Water Right
2-7456
(IRRIGATION)

Exam for Permit 02-7456
Pictures taken 9/28/2009 by kw

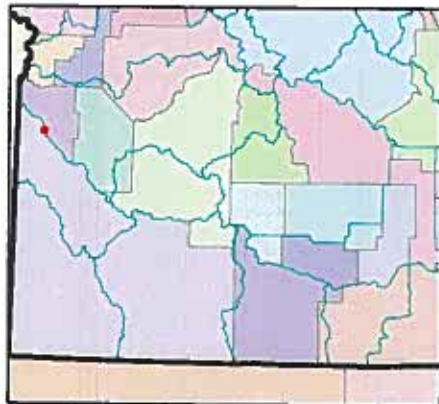
Use found to be 1 acre of irrigation - this includes area previously in orchard that became diseased and had to be removed. Also wildlife area on riverbank & hill side below right holder's home & lawn. Wildlife

Water Right
2-7456
(WILDLIFE)

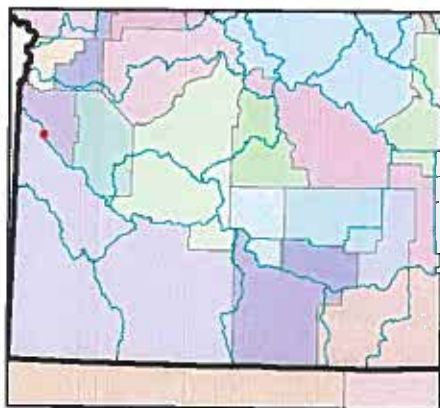
includes birds, fox, coyotes - they would also have access to river so recommend minimum volume for this use.
